**Meeting of the Mashpee Planning Board
Wednesday, September 4, 2019
Waquoit Meeting Room, 7:00 PM**

**Mashpee Planning Board
Minutes of Meeting
August 21, 2019 at 7:00 p.m.
Mashpee Town Hall-Waquoit Meeting Room
16 Great Neck Road North
Approved 10/2/19**

UTILITY, GRADING, DRAINAGE & EROSION CONTROL PLAN FOR CAPE COD COFFEE LOT B/#10 EVERGREEN CIRCLE - MASHPEE, MA JUNE 21, 2019 Sheet 4 of 6 JOB NUMBER 3110.00

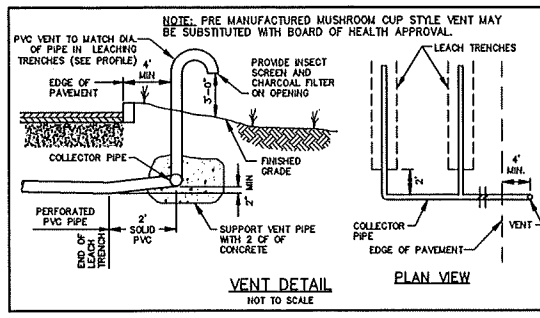
1. *The details that are in front of the main entrance on the left of the building (at the donut truck) are not consistent with the site plan as shown on Sheet 4 of 6.*

The site plan (Sheet 3 of 6) shows a total floor area of under 10,000 square feet however, the total footprint of the building including the covered porch and covered pavilion is 11,784 square feet.

The proposed grading shown on Sheet 4 takes into account the additional finish coat of pavement. The note from Sheet 2 has been carried over to Sheet 4 for clarity.

Additional spot grades are provided on Sheet 4.

Additional spot grades are shown on Sheet 4.

Inverts are shown for the roof drains on Sheet 4.

A note has been added to the detail on Sheet 4 and this is also noted on Paeg 2 of the Operation & Maintenance plan submitted as Appendix D to the Stormwater Report.

Notes regarding sediment contamination during construction has been added to Sheet 4 and to the appropriate details on Sheet 6.
